4S Ranch, Bulverde and ETJ

Water Quality Permit amendment

Flood Insurance Rate Map

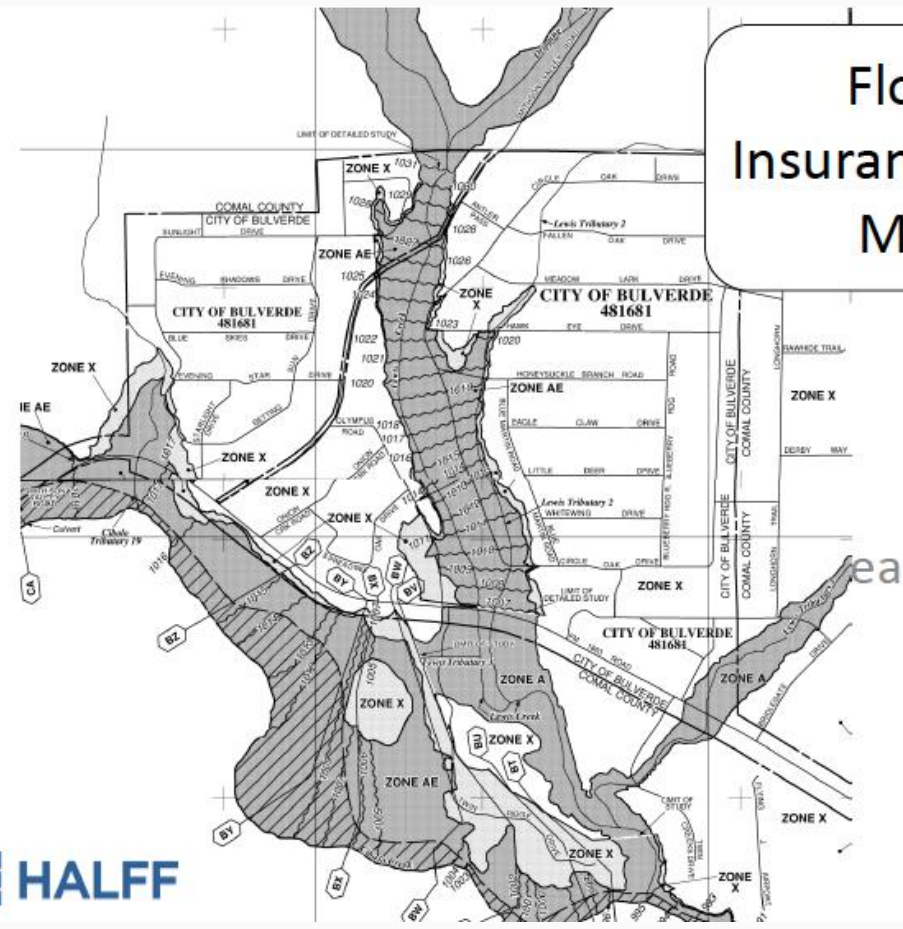
Are you aware the developers map in the public notice shows an outdated version of the flood plain?
